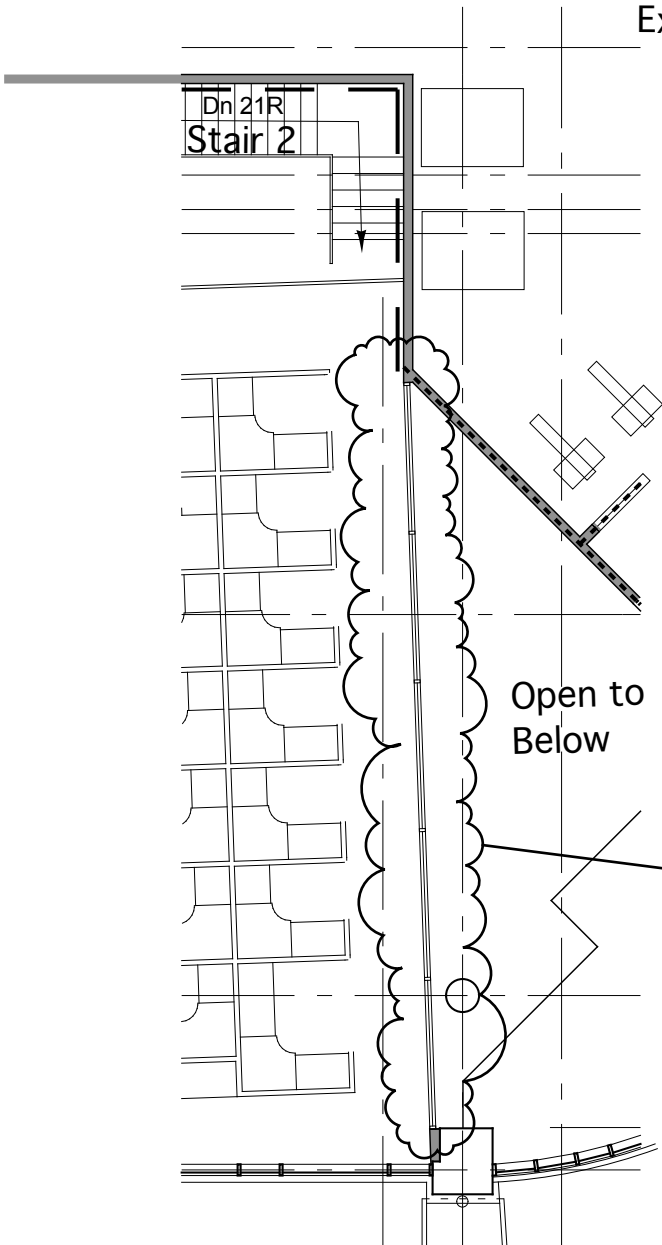
The portion of the partition that is clouded was not correctly designated as a smoke partition on Sht. A1.2. It is a smoke partition - seal all penetrations as required.
